# Crown Street upgrade

Community Meeting – Tuesday 28 February 2023

# **CROWN STREET, SURRY HILLS DEVONSHIRE ST TO OXFORD ST UPGRADE**

# Peer Review Aim

# Peer Review Concept Design

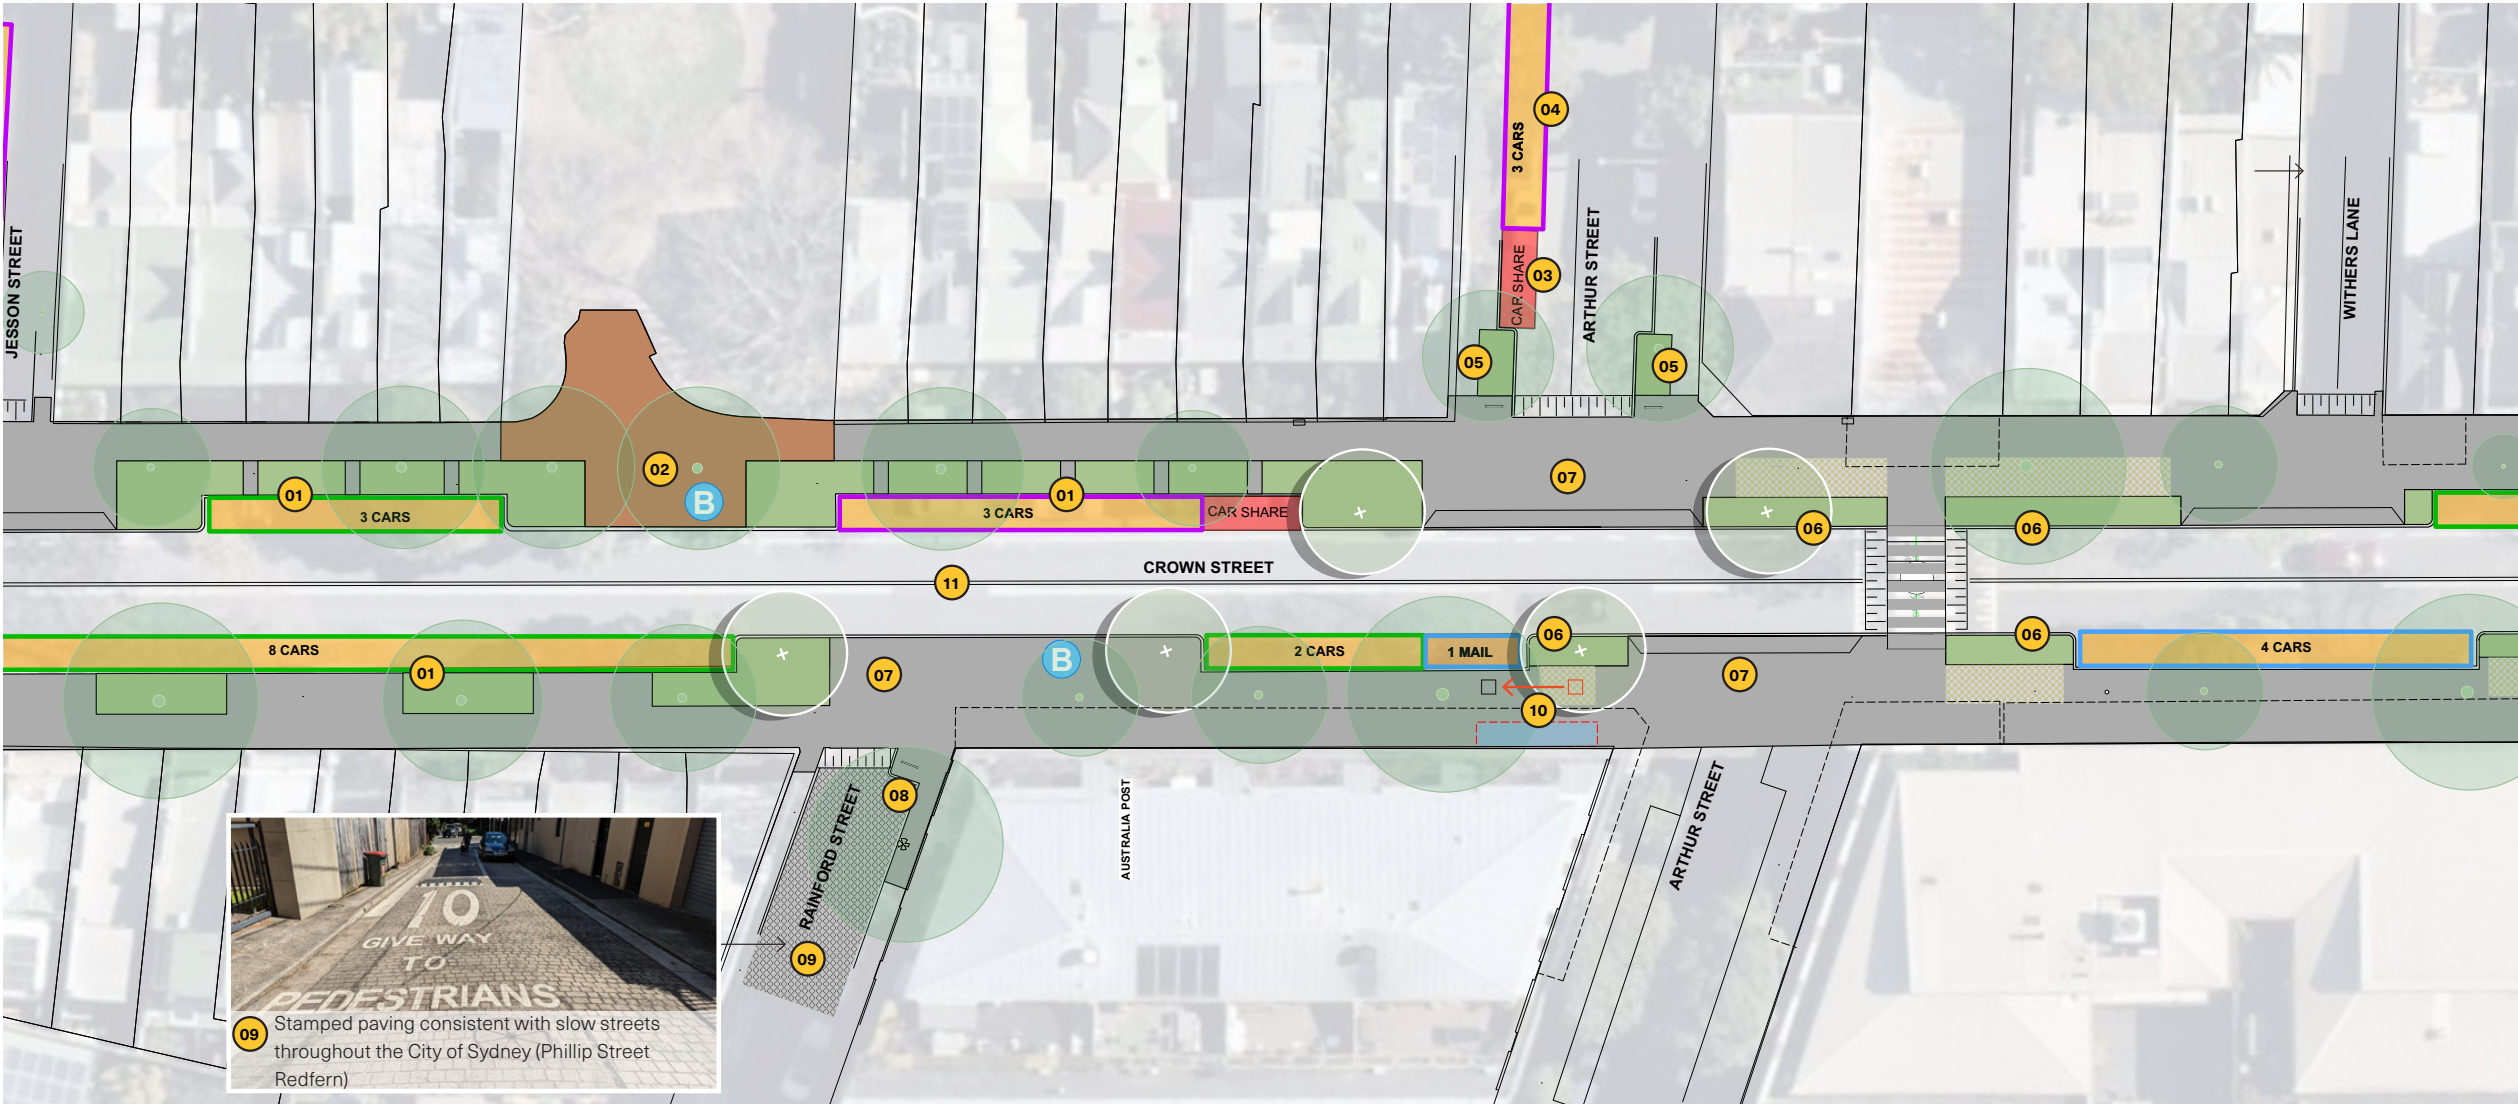
Kerb alignment adjusted (to minimum compliant parking space width) to maximise footpath and planting space. Continuous planting bed provided with intermittent pavements for access to parked vehicles.
2.

Bus stop 'in the park' - in-lane bus stop located to align with Tudor St park, with existing brick paving to full width of Tudor St lot boundary to be retained.
3.

Relocate 1 no. existing car share parking space from outside The Clock Hotel to Arthur St.
4.

Convert 4 no. existing unmarked 2P parking spaces on Arthur St to 3 no. marked 2P parking spaces.
5.

Kerb extensions to Arthur St to provide additional space for planting and bike parking, and lane narrowing for traffic calming.
6.

New kerb extension to create activation area with kerbside planting, and additional street trees at existing commercial premises.
7.

Continuous footpath treatment and kerb extension where side streets.
8.

Kerb extension to Rainford St to provide additional space for new bike parking.
9.

New shared zone with stamped pavement to Rainford St, to be consistent with other typical City of Sydney laneway shared zones (subject to further investigation and TfNSW approval).
10.

Minor relocation of existing mail box to provide additional activation area.
11.

Speed reduction to Crown Street to 30km/h (subject to TfNSW approval).
